Office Action Summary

09/924,004

PEREL ET AL.

DETAILED ACTION

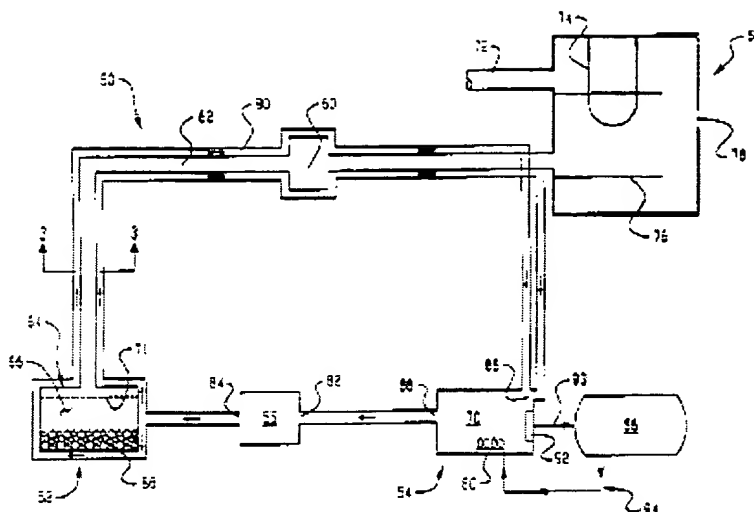
Horsky discloses an ion source (FIG. 2, element 58) for an ion implanter, comprising:

a sublimator (FIG. 2, element 52) having a cavity (FIG. 2, element 66) for receiving a source material (FIG. 2, element 68) to be sublimated and for sublimating the source material;

an ionization chamber (FIG. 2, element 58) for ionizing the sublimated source material, said ionization chamber located remotely from said sublimator (FIG. 2); and

a feed tube (FIG. 2, element 62) for connecting said sublimator (FIG. 2, element 52) to said ionization chamber (FIG. 2, element 58).

Referring to claims 2, 10: further comprising a heating medium (FIG. 2, element 70) for heating at least a portion of said sublimator (FIG. 2, element 52) and said feed tube (FIG. 2, element 62), and a control mechanism for controlling the temperature of said heating medium (FIG. 2, element 70).

Referring to claims 3, 11: wherein said control mechanism comprises a heating element (FIG. 2, element 80) for heating the heating medium (FIG. 2, element 70), a pump (FIG. 2,

element 55) for circulating said heating medium, at least one thermocouple (FIG. 2, element 92) for providing temperature feedback from said heating medium (FIG. 2, element 70), and a controller (FIG. 2, element 56) responsive to said temperature feedback to output a first control signal (FIG. 2, element 94) to said heating element.

Horsky does not disclose the comprising of a gas injector for injecting gas into said cavity.

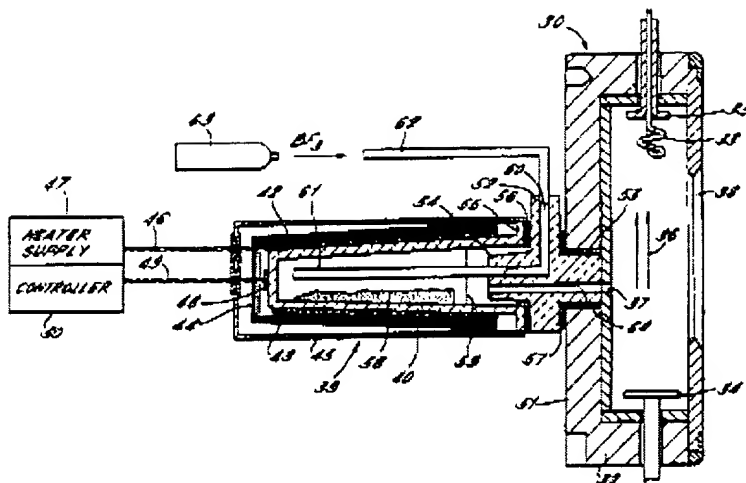
However, Foad discloses an ion source for ion implantation apparatus that comprises a gas injector (FIG. 2, element 61) for injecting gas into a cavity of a crucible (FIG. 2, element 40).

Therefore, it would have been obvious for one having ordinary skill in the art at the time the invention was made to include the gas injector for injecting gas as disclosed by Foad into the cavity of the crucible disclosed by Horsky. The motivation of doing so is to achieve higher proportion of ions extracted from the arc chamber in order to gain the beam current implanted on the target substrate as taught by Foad (column 8, line 10-16).
